TUSKAWILLA UNITED METHODIST CHURCH
3925 RED BUG LAKE RD, CASSELBERRY, FL

PRELIMINARY SUBDIVISION PLAN

C1.0

PRELIM. SUBDIVISION PLAN
1" = 40'

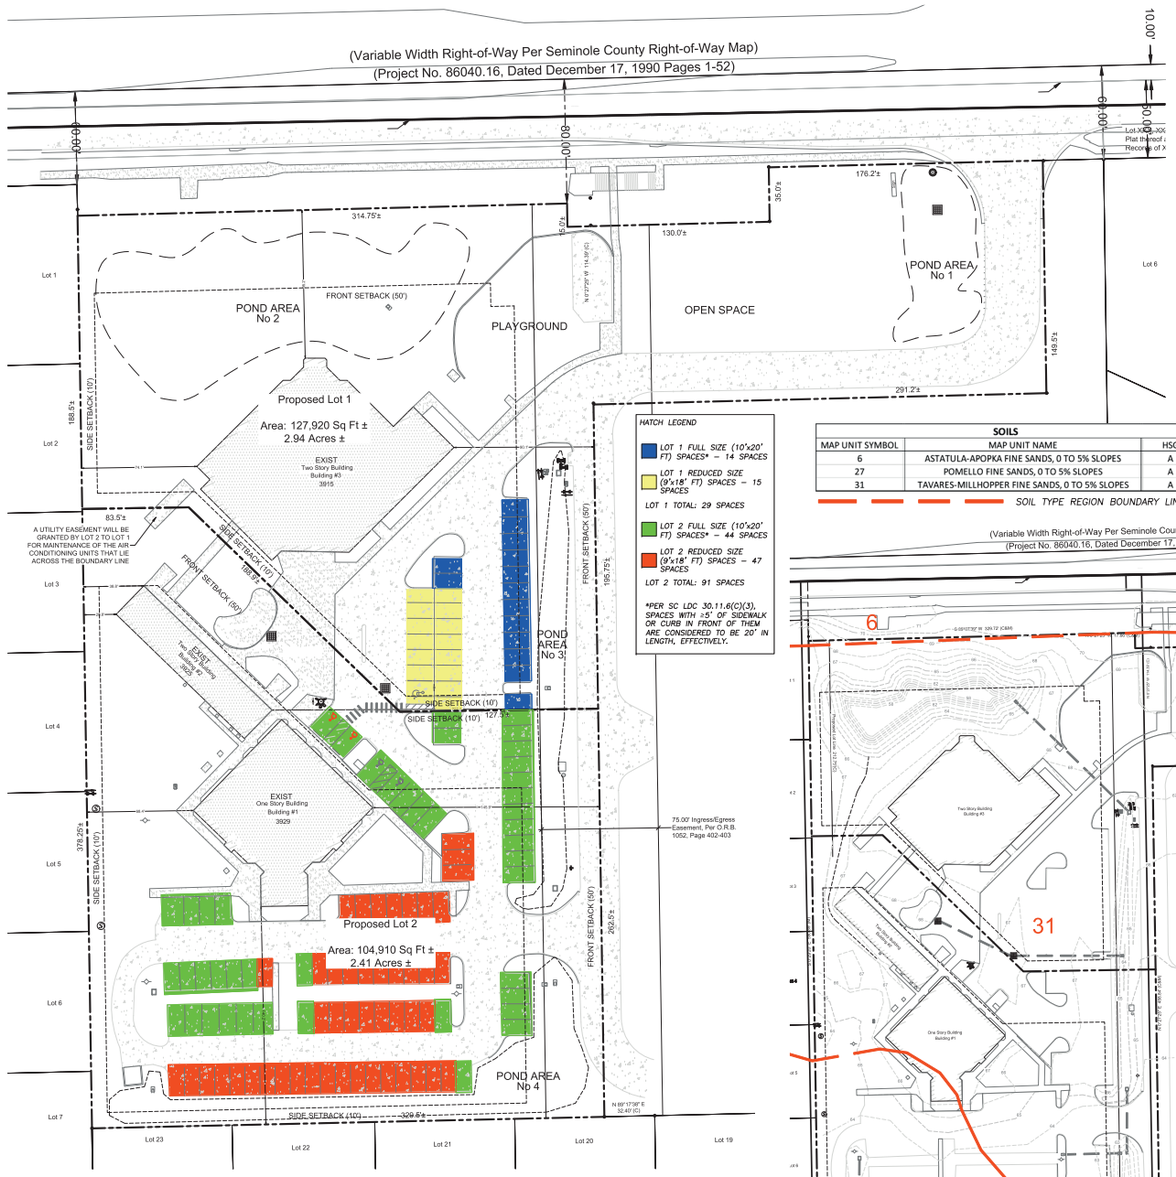
FIRE SAFETY COMMENTS:
- DUE TO THE CHANGE OF USE AND POTENTIAL REQUIREMENTS FROM OTHER DEPARTMENTS THIS MAY CHANGE THE REQUIRED FIRE DEPARTMENT ACCESS. PLEASE ACKNOWLEDGE THE FOLLOWING WILL BE MAINTAINED FOR FIRE DEPARTMENT ACCESS IN ACCORDANCE WITH NFPA 1, CHAPTER 18: FIRE DEPARTMENT ACCESS ROAD SHALL HAVE AN UNOBSTRUCTED WIDTH OF NOT LESS THAN 20 FT IN ACCORDANCE WITH THE SPECIFICATIONS OF NFPA 1, SECTION 18.2.3.5.1.1 ACCESS TO A DOOR: FIRE DEPARTMENT ACCESS ROADS SHALL EXTEND TO WITHIN 50 FT OF AT LEAST ONE EXTERIOR DOOR THAT CAN BE OPENED FROM THE OUTSIDE AND THAT PROVIDES ACCESS TO THE INTERIOR OF THE BUILDING PER SECTION 18.2.3.2.1 NFPA 1 HOSE LAY: FIRE DEPARTMENT ACCESS ROADS SHALL BE PROVIDED SUCH THAT ANY PORTION OF THE FACILITY OR ANY PORTION OF AN EXTERIOR WALL OF THE FIRST FLOOR OF THE BUILDING IS LOCATED NOT MORE THAN 150 FT (450 FT IF EQUIPPED WITH AN AUTOMATIC FIRE SPRINKLER SYSTEM) FROM FIRE DEPARTMENT ACCESS ROADS MEASURED BY AN APPROVED ROUTE AROUND THE EXTERIOR OF THE BUILDING OR FACILITY (SECTION 18.2.3.2.2 AND 18.2.3.2.2.1 NFPA 1)

- THE POTENTIAL CHANGES MAY ALSO IMPACT THE FIRE DEPARTMENT TURNING RADIUS. PLEASE PROVIDE TURNING RADIUS ANALYSIS IF ANY PROPOSED CHANGE. INCLUDE TURNING RADIUS ANALYSIS WITH PLANS.

- A CHANGE OF OCCUPANCY CLASSIFICATION WILL REQUIRE A PERMIT AND POSSIBLY AN ALTERATION TO THE EXISTING STRUCTURE TO COMPLY WITH CURRENT CODE (7TH ED FFPC TO INCLUDE NFPA 1 AND 101 2018 ED.) EXAM LE: BUSINESS TO MERCANTILE, RESIDENTIAL TO COMMERCIAL

- PER NFPA 101, CHAPTER 14, EDUCATIONAL BUILDINGS SHALL BE PROTECTED THROUGHOUT BY AN APPROVED, SUPERVISED AUTOMATIC SPRINKLER SYSTEM IN ACCORDANCE WITH 9.7.
